VILLAGE OF KIMBERLY, WI
NOTICE OF VILLAGE PLAN COMMISSION MEETING

ITEM DESCRIPTION: Aspire Phase 2 Site & Building Plan Review

Re: Site Plan & Stormwater Management Plan Review
Aspire-Phase II (Heritage-MSP Kimberly)
McM. No. K0001-09-24-00338.04

SHEET NO. **1R**
 FILE NO. M7-D-393

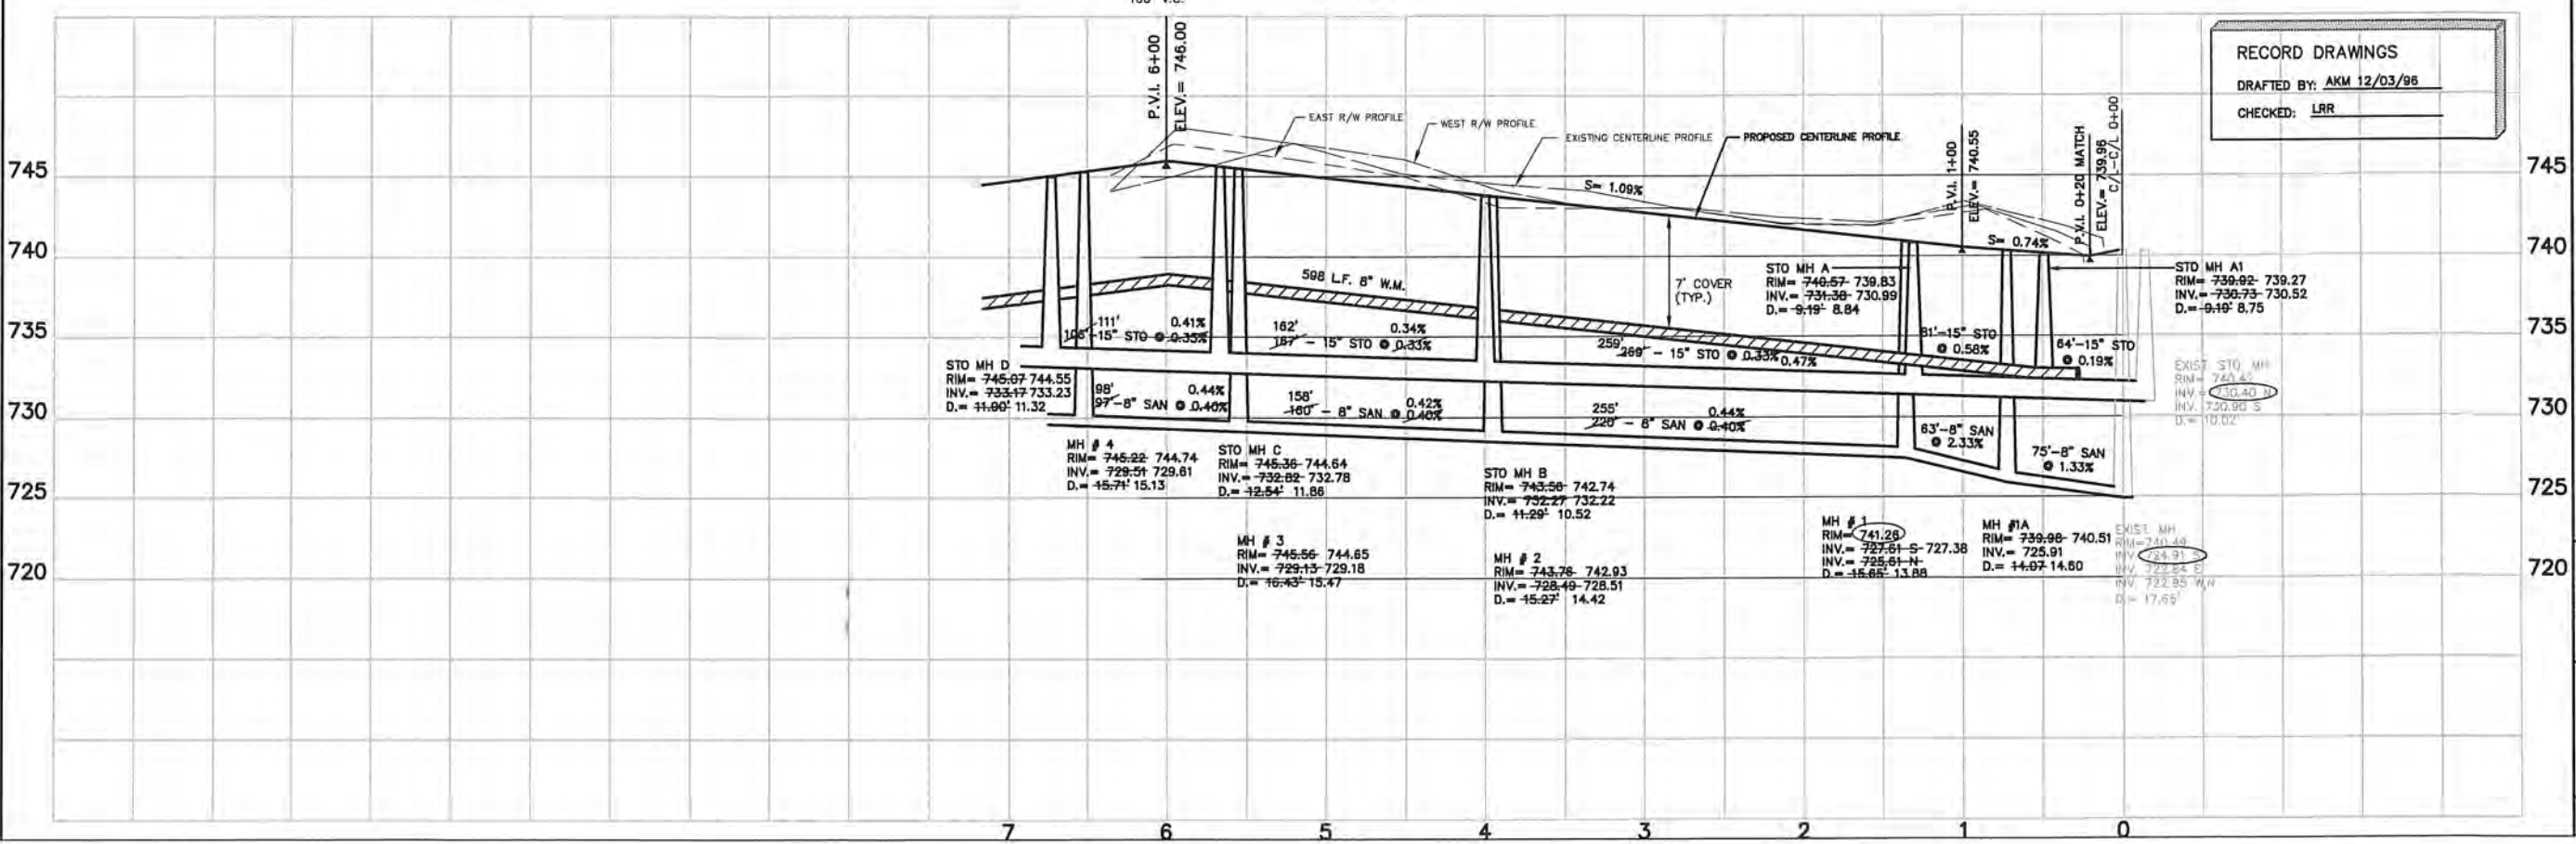
1. An existing 6-inch sanitary lateral exists for the new expansion and should be used. (See the attached record drawing for the location and approximate depth.)

4. An existing 6-inch sanitary lateral exists for the new expansion and should be used. See the attached record drawing for the location and approximate depth.

SITE GRADING PLAN C2.0

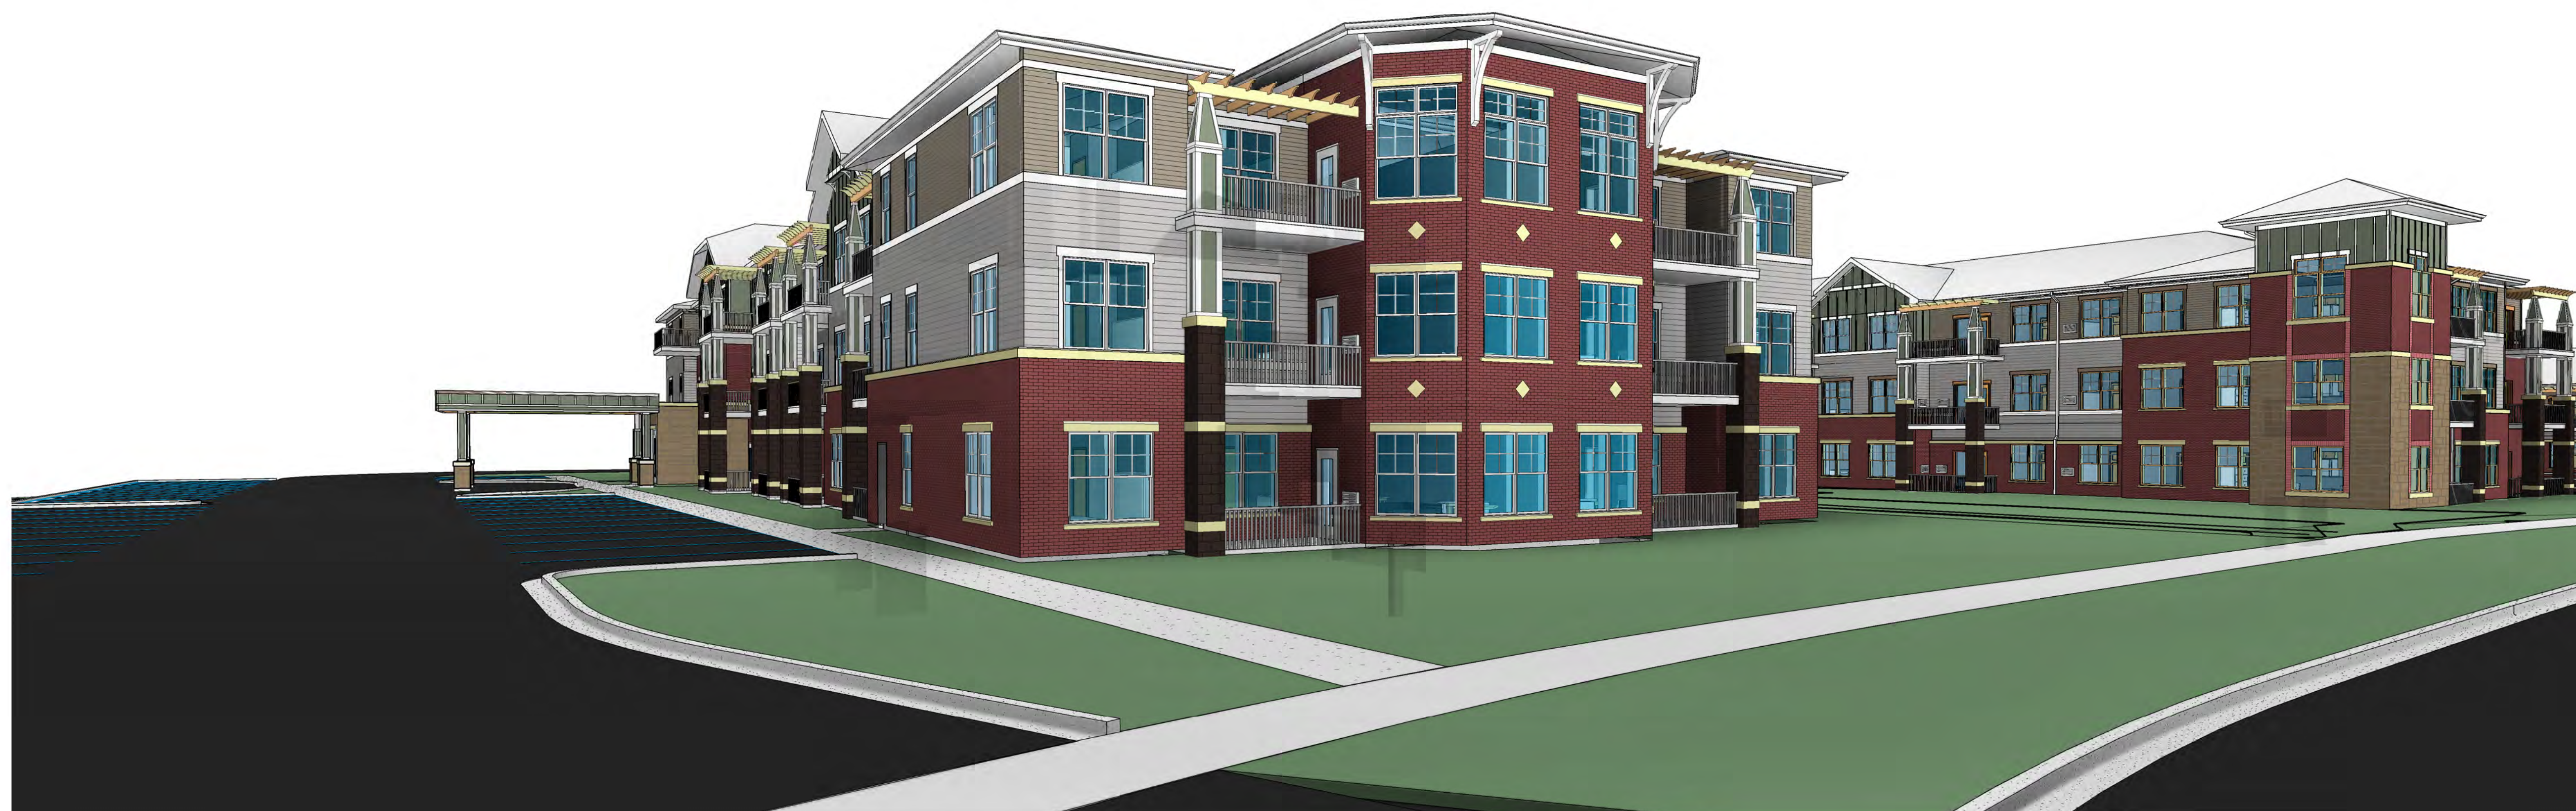
- iv. Summary of overall impervious and pervious areas is required.
2. Site/Grading Plan
 - a. North lot line spot elevation required to ensure proper drainage.

- b. Drainage of pickleball court area to be addressed.
 - c. East lot line spot elevations required to ensure proper drainage.
3. Erosion Control
 - a. An Erosion Control Plan is required.

3. Drainage along the rear yards of Railroad Street also requires collection of runoff so it does not impact those properties. (see attached markup)
4. More detail is needed as to how drainage around the pickleball courts will be handled. Currently it appears as though the water from the court has no discharge point. How does this surface water drain to the pond?
